Case #: ZBA 2011-15
Date: March 3, 2011
Recommendation: Conditional Approval

PLANNING STAFF REPORT

Site: 26 Hamilton Rd

Legal Notice: Applicant and Owner, Matthew Barnes, seeks a special permit to alter a nonconforming structure under SZO §4.4.1 to construct a dormer on an existing two-family residence.

*26 Hamilton Road: Building on the right (above),
Center of image (left)*

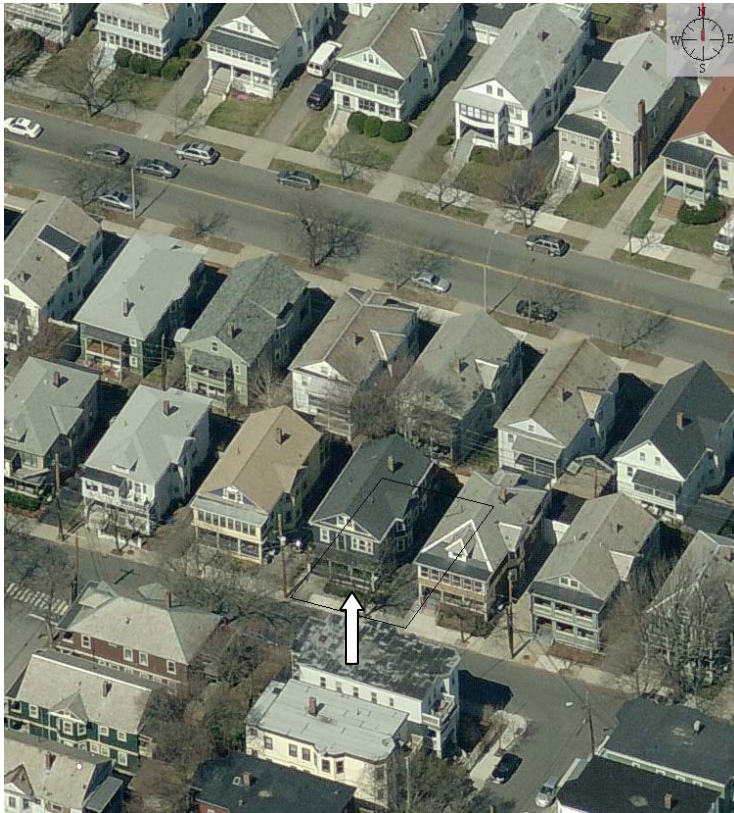
The dormer as proposed has several elements that could be redesigned to improve its appearance. The dormer should start below the ridge and back from the sidewall of the house to reduce its prominence. The dormer should have as steep a slope as possible. If the sink in the bathroom was relocated to be next to the door, the dormer would not have to have the full head height at the outermost portion of the dormer and it could have a more significant slope. Also, the eave should not be broken because doing so would further alter the original structure. The dormer has four large windows and although windows add interest to dormers, the proposed windows do not relate to the windows on the rest of the house in style or location. Additionally, the windows are placed such that the wall between the bedroom and the bathroom falls in the middle of a window.

- The front wall of the dormer should be set back at a minimum of 1 foot 6 inches from the main wall of the structure.
- The eave of the house should not be altered.
- The dormer should be set back at a minimum of 1 foot off of the ridgeline of the structure.
- The windows should account for a large portion of the dormer's front wall and should either be symmetrical or relate to the windows below. The wall between the bedroom and bathroom should not be visible in the middle of a window.
- The sink should be relocated to another part of the bathroom and the pitch of the dormer should be made as close to a 6:12 pitch as possible.
